**Rear Suspension Hub Carrier Fulcrum Bolts –
Revised Specification –
Replace – Service Action S468****MODEL**1998 MY XK8 Range
1998 MY V8 XJ Series**VIN**025588-026519
837386-840302**Issue:**

ILLUSTRATION 1

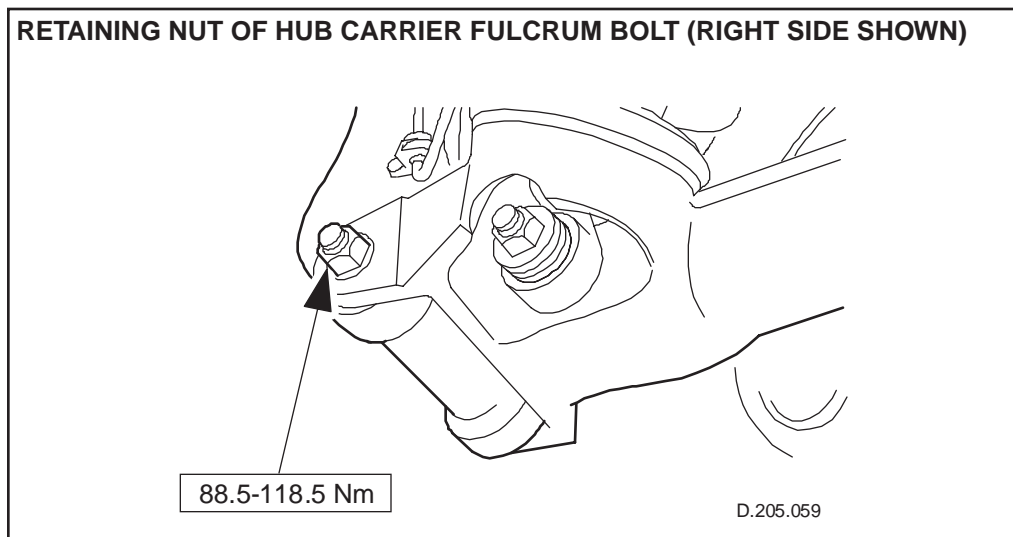
1. Raise the vehicle on a lift so that the rear suspension arms are supported while still allowing access to the nut (Illustration 1) and also to the head of the fulcrum bolt (Illustration 2).

ILLUSTRATION 2

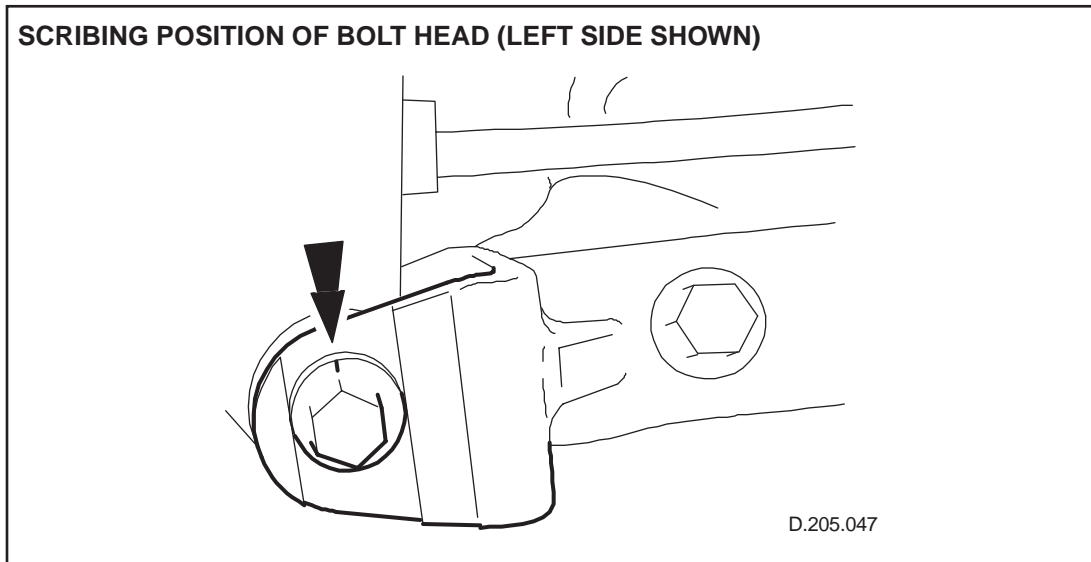
2. Remove the rear road wheels.
3. If necessary, clean the head of each fulcrum bolt so as to be able to identify the marker line stamped on the head of each bolt (Illustration 2). Use a fine-pointed scribe to mark on each wishbone the location of the marker line, prior to dismantling. The marker line will not necessarily be in the location illustrated, depending on previous adjustment to effect correct wheel alignment.

6. While still supporting the hub carrier in position, install the replacement bolt from the rear. Rotate the bolt as necessary to allow the eccentric head of the bolt to fully seat in the guide slot in the wishbone. Align the marker line on the head of the bolt with the line previously scribed on the wishbone in step 3. Install the washer with a **new** self-locking nut, and tighten until the bolt begins to grip, ensuring that the marker line on the bolt head remains aligned to the scribed line.
